RE: TRAFFIC IMPACT STATEMENT FOR A PARK WITH PICKLEBALL AND BASKETBALL COURTS, ASHLER HILLS DRIVE AT 74TH WAY – PHOENIX, SCOTTSDALE

1st Submittal

Reviewer Name, Agency: **Phil Kercher & Parker Murphy, City of Scottsdale**

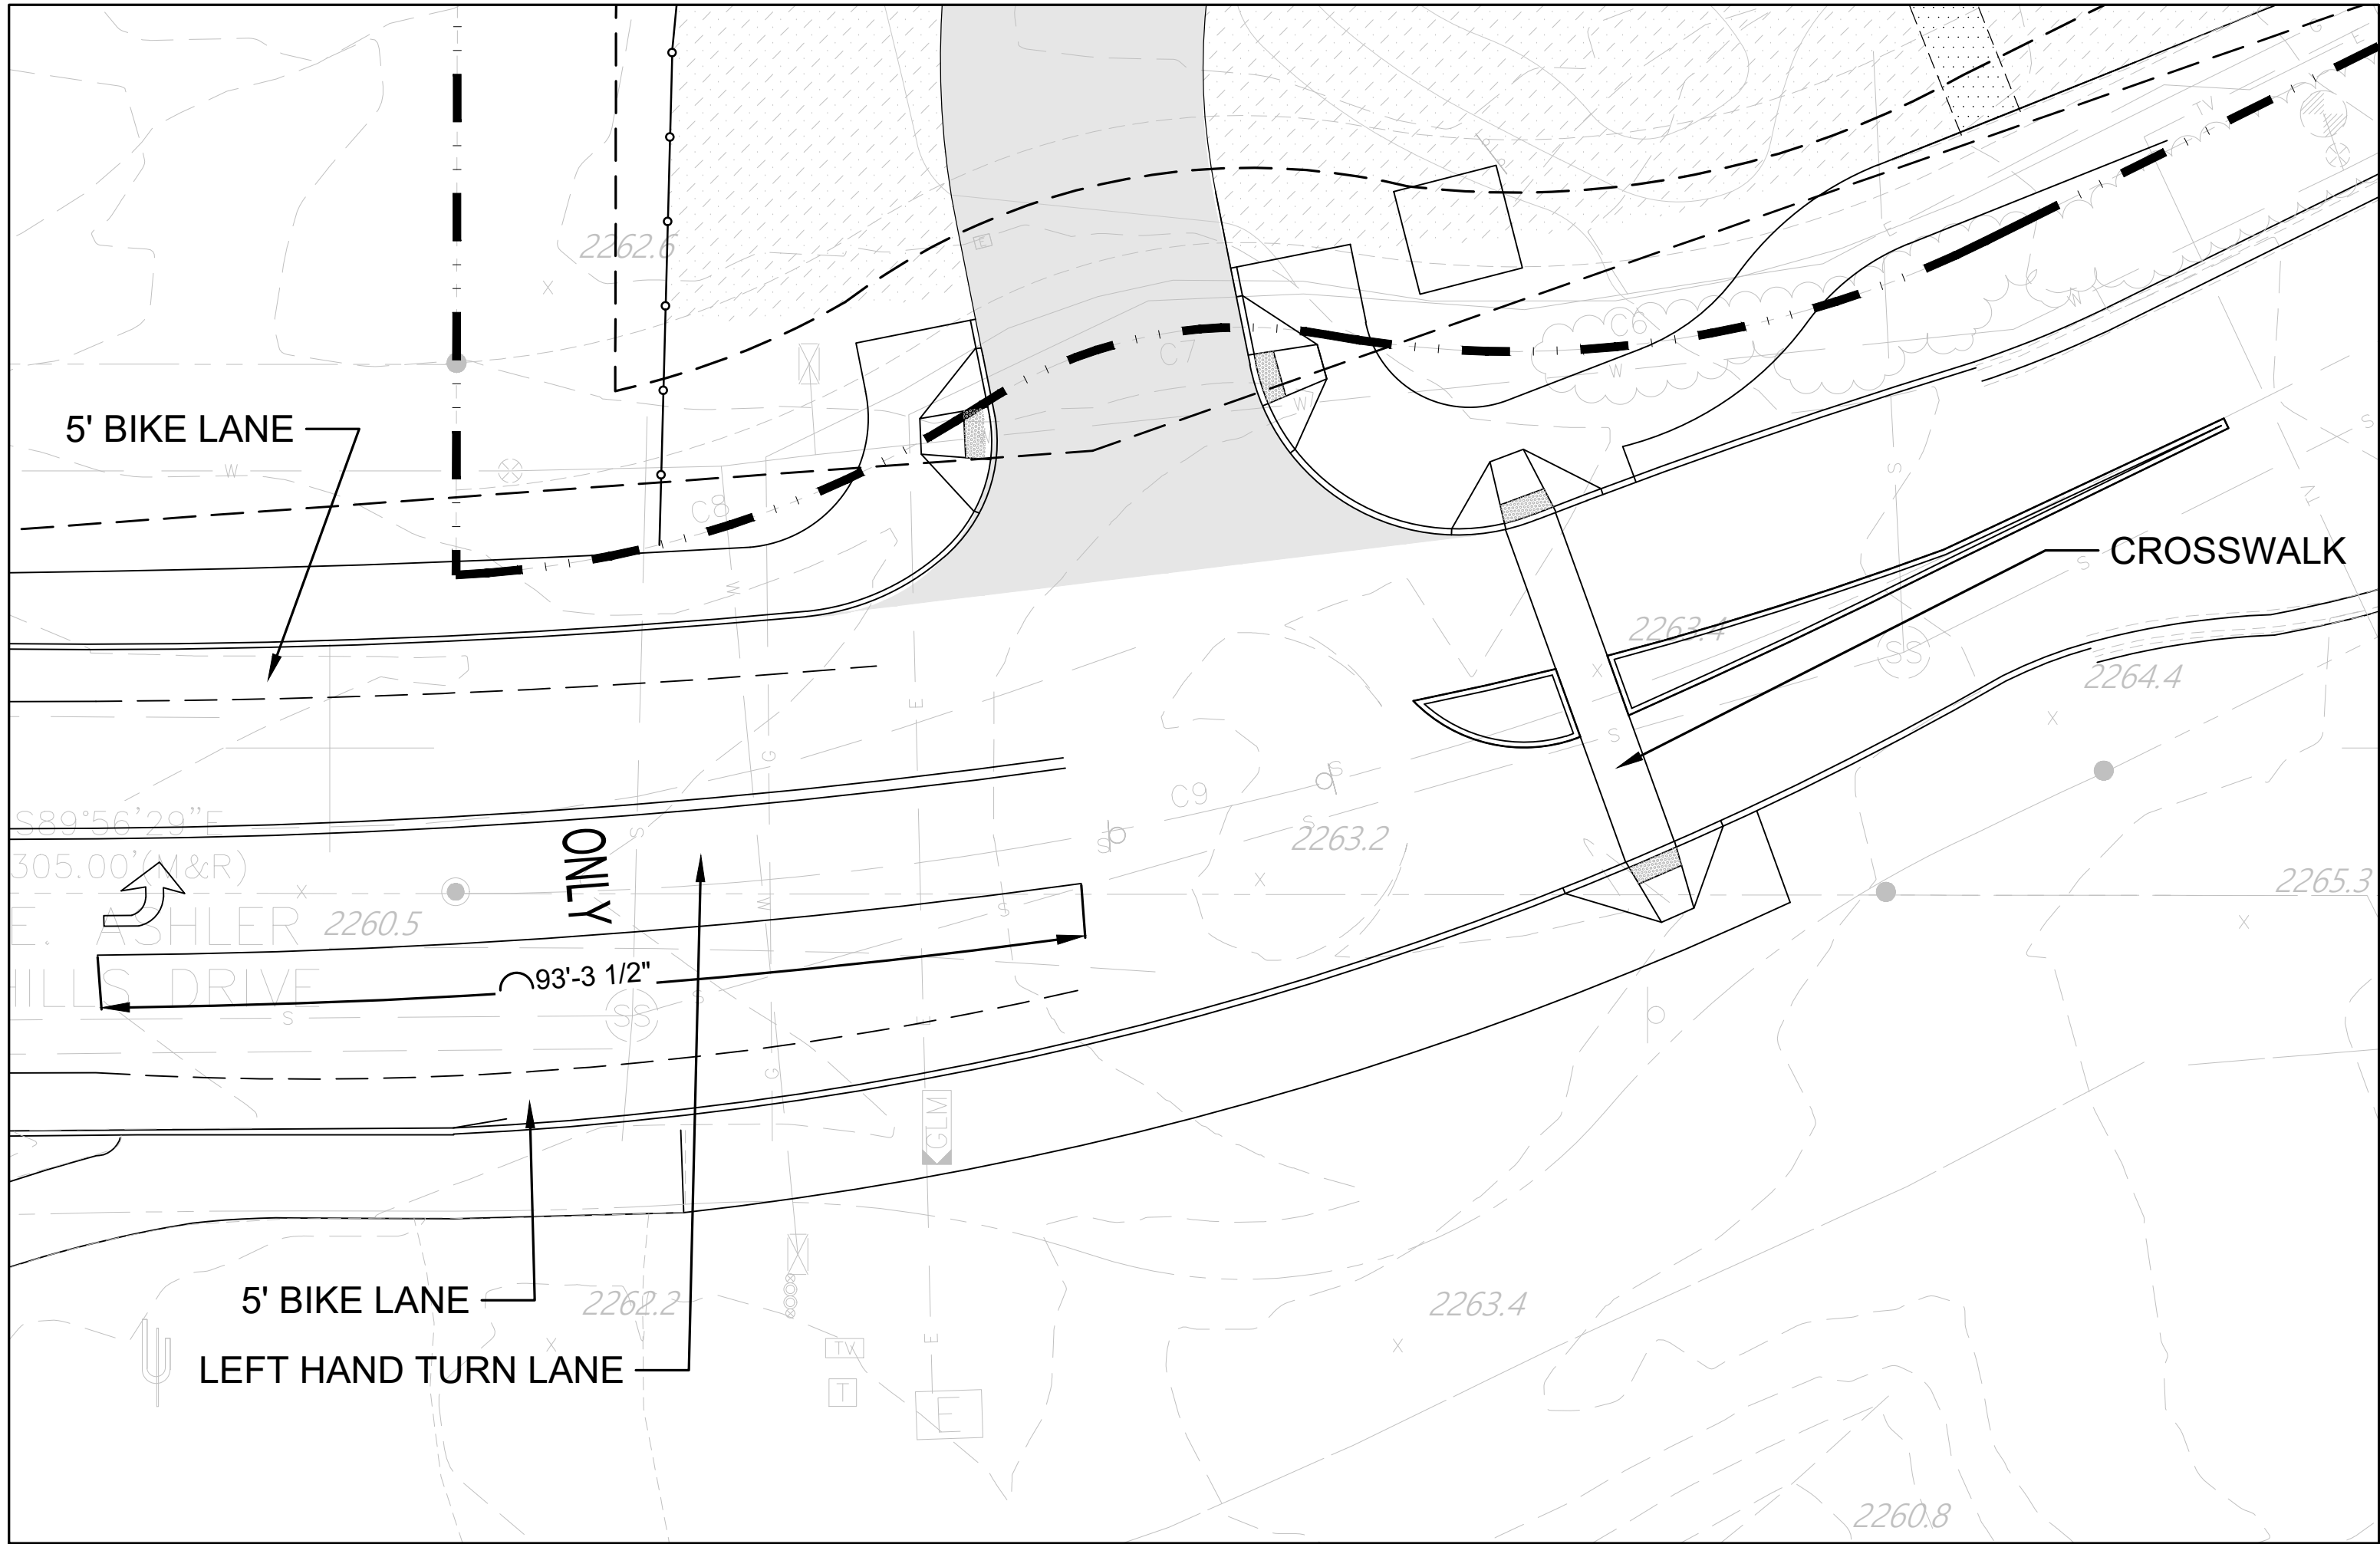
Item	Review Comment	(Code) & Response
1.	Transportation - The site driveway should be designed in conformance with COS Driveway Type CL-1, COS Standard Detail #2256. The sidewalk across the driveway should be modified to conform to the driveway detail, not be separated so far from the curb line. DSPM 5-3.200; DSPM Sec. 5-3.205; COS Standard Detail Drawings - 2020 revision.	(1) Will comply. The design standard details is included as part of the attachments.

3.	Transportation - Staff suggests moving the site driveway west of the traffic circle to improve sight triangle, or at circle but remove center island. Conceptual plan sent to CPM.	(1) The proposed driveway is now proposed to be at the roundabout.
